ADDENDUM NO. 4
Request for Tender No. 24-01-00517

Milton Town Hall & Fire Station No. 2
HVAC Equipment Replacement

ADDENDUM No. 4

PROJECT:	H.V.A.C. Replacement at Town Hall & Fire Station #2	DATE:	23 Oct. 2024
PROJECT #:	24034	FROM:	Binayak Raj Maurya
TO:	Town of Milton	ATTENTION:	Daniele Santos

1 TOWN HALL GROUND FLOOR – MECHANICAL DEMOLITION PLAN  
M1.1 SCALE: 1:75

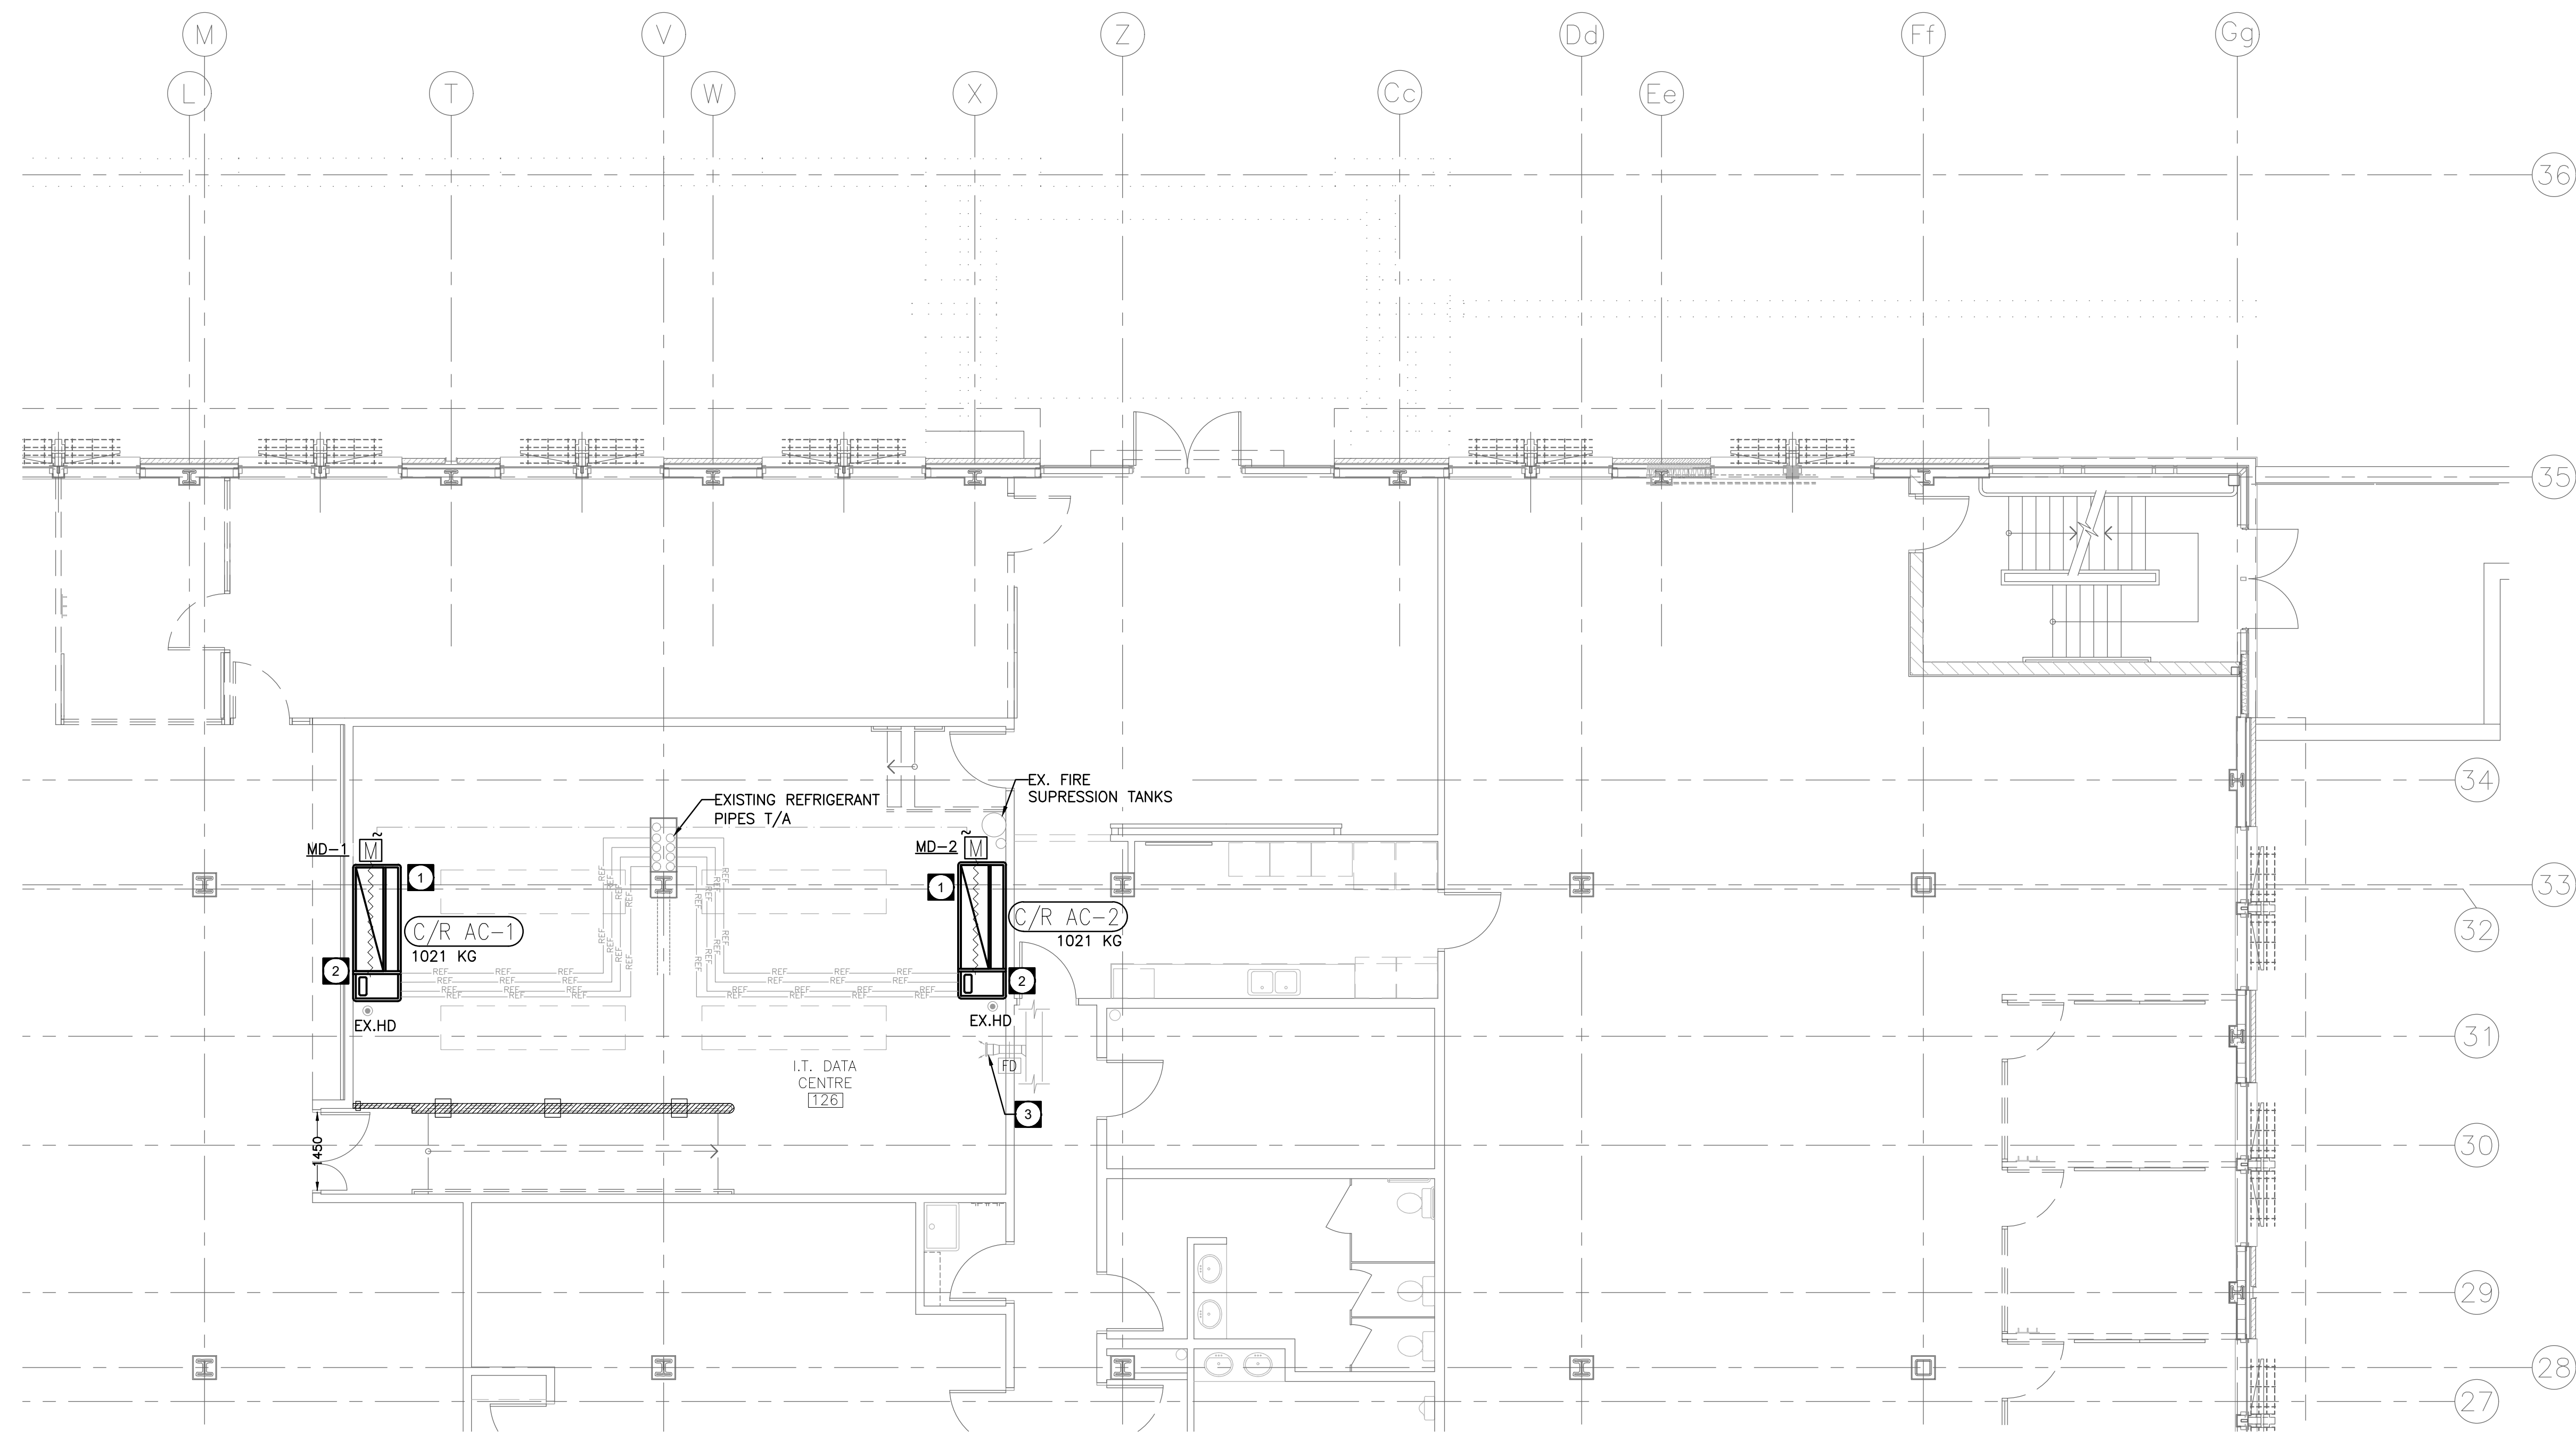
Addendum 3, Question 5:

Can you confirm whether there is a fire suppression system under the Data Centre raised flooring.

Addendum 3, Question 6:

Can you confirm whether the raised floor can withstand the weight of wheeling the units in and out of the Data Centre?

1.4 Refer to Mechanical Drawing M1.1 Rev. C

- Revised note 'B'.

REVISED ANSWER:

There is fire suppression system under the flooring. Refer to “Mechanical Drawing M1.1 Rev. C - Revised note B” and “Mechanical Drawing M1.4 Rev. C Revised note 2”.

- B** TEMPORARILY DISMANTLE HAND RAILS, RAMP, RAISED FLOOR TILES, FLOOR GRID AND PEDESTALS, CEILING TILES FOR TRANSPORT AND INSTALLATION OF NEW OR EXISTING C/R AC UNITS. RESTORE TO ORIGINAL CONDITION. PROVIDE ALL NECESSARY SUPPORT BLOCKS, PLYWOOD, SHEET METAL, LIFTING MECHANISM ON CONCRETE SLAB AND EXISTING SERVICES SUCH AS ELECTRICAL & IT CONDUITS, MECHANICAL PIPING, FIRE SUPPRESSION LINES ETC. NEW AND EXISTING C/R AC UNITS SHALL NOT BE PLACED OR ROLLED OVER EXISTING SERVICES AND EQUIPMENT. CONTRACTOR SHALL BE RESPONSIBLE FOR ADEQUATE PROTECTION OF ALL SERVICES.
